2020 Annual Update - Small Areas

EPC Review - Hearing January 21, 2021

Exhibit A to the
Memo for the IDO Annual Update 2020 –
Application for Amendment to the IDO Text – Small Area

3-6(D) COORS BOULEVARD – VPO-1

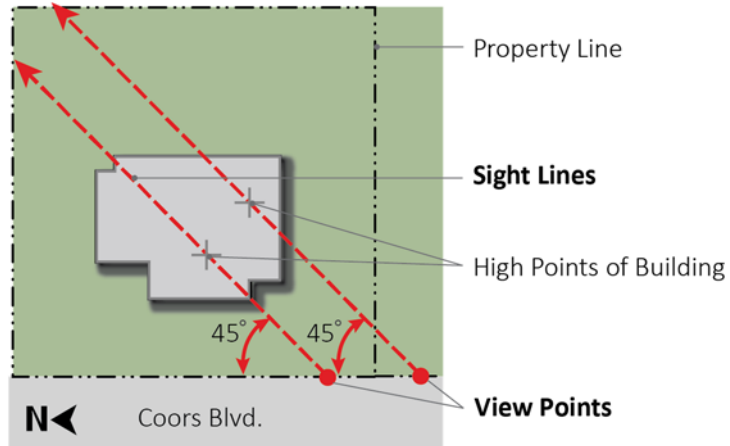
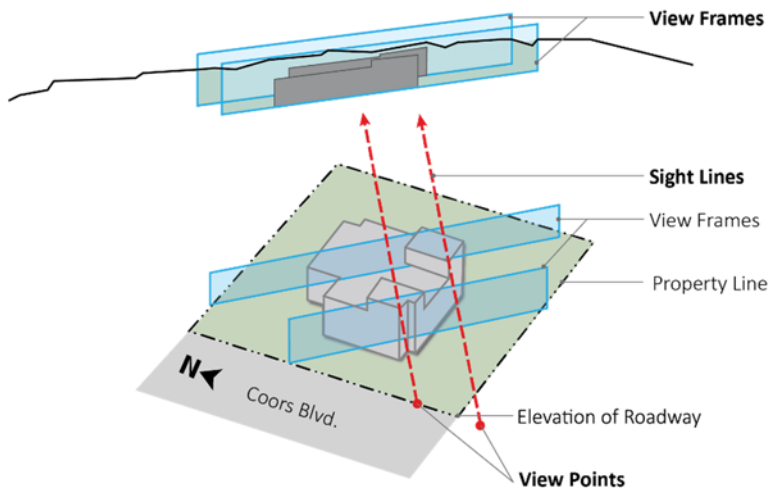
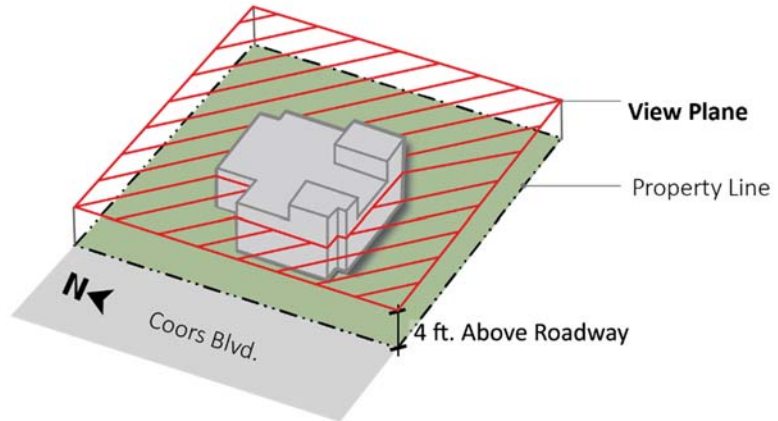
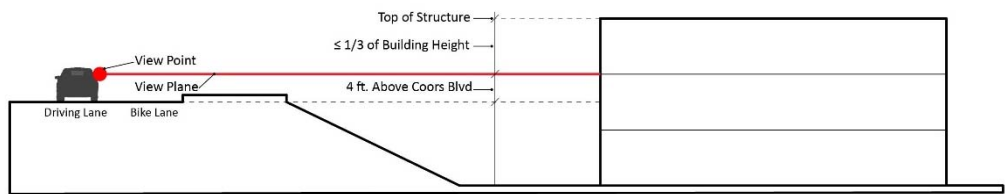
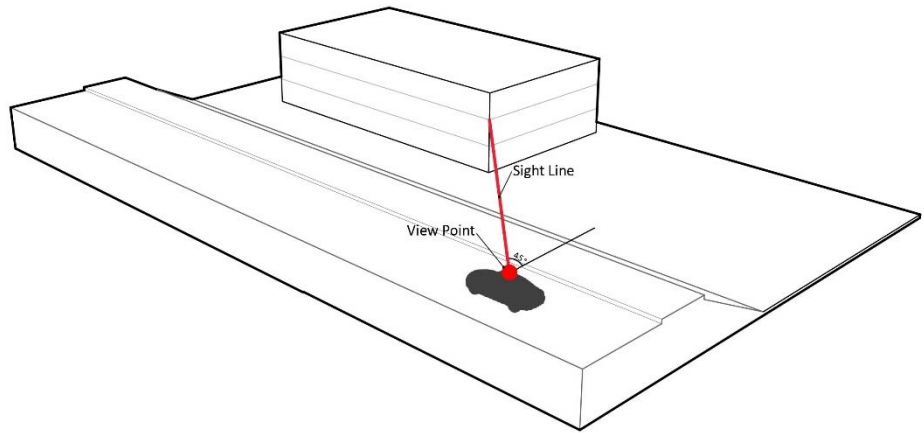
Page	Section	Change / Discussion	Explanation
130	3-6(D)	Coors Boulevard VPO-1 Revise as shown in Exhibit 3-6(D) - Coors Boulevard VPO-2.	Incorporates changes proposed with the 2019 IDO update and clarifies issues raised during the EPC process in 2020. Generally, these changes specify what view is protected, the view point that view is taken from, defined terms, and more specific methodology about how to perform the view analysis. The changes clarify that the sight line is used for both the building height and bulk analyses and that more than one sight line may be required. Finally, minor revisions to the graphics are proposed to add clarity. See Exhibit 3-6(D).
132	3-6(D)(5)	Coors Boulevard VPO-1 Add a new Subsection with text as follows and renumber subsequent subsections accordingly: <u>"No height bonuses allowed by Table 5-1-2 for Workforce Housing or Structured Parking are allowed."</u>	Removes the bonus height available on Major Transit (MT) corridors, added in the 2019 IDO annual update. While the VPO-1 regulations would prevail any underlying zoning allowances, this provision makes it explicit that the 12-foot Workforce Housing Height Bonus is not applicable in the Coors VPO-1. See additional explanation in Council Services Memo - Small Areas.

1. Lines that begin at each view point along Coors Boulevard, looking toward the ridgeline of the Sandia Mountains at a 45 degree angle from the east edge of the roadway.
2. Sight lines are required to intersect the highest point(s) of the proposed building(s) on the site. If the building has no higher point is all the same height, a sight line shall begin at a view point at the lowest elevation(s) of the public right-of-way of Coors Boulevard abutting or nearest to the site that allows the sight line to pass through the building.
3. The sight line is used as the perspective for the analysis in Subsections 14-16-3-6(D)(5)(a) (Building Height) and 14-16-3-6(D)(5)(b) (Building Bulk). Multiple sight lines may be required depending on the size of the site and shape of the building(s). (See figure below.)

A vertical rectangular frame drawn perpendicular (i.e. 90 degrees) to a given sight line **through the highest point of the proposed building**. The top of the view frame is established by the highest visible point of the Sandia ridgeline within the view frame. The bottom of the view frame is the elevation of the public right-of-way of Coors Boulevard where the sight line begins. The left and right edges of the view frame are an upward projection of the property lines at the site boundary where the view frame intersects the property lines. As many view frames as necessary to capture all the sight lines on a site are required. (See figure below.)

A **horizontal view** plane 4 feet above the elevation of the east edge of the east driving lane on Coors Boulevard, **based on the elevation of the view point for a given sight line, and extending horizontally above the sites located east of Coors Boulevard considering the perspective that would be seen along the sight line. Multiple view planes may be required if the elevation of Coors Boulevard varies across the site.** (See figure below.)

No more than 1/3 of the height of structures (including building parapets, mechanical equipment and associated screening, walls, and fences) shall be allowed to penetrate above the view plane as seen along each sight line and as shown in section diagram below, with the following exceptions:
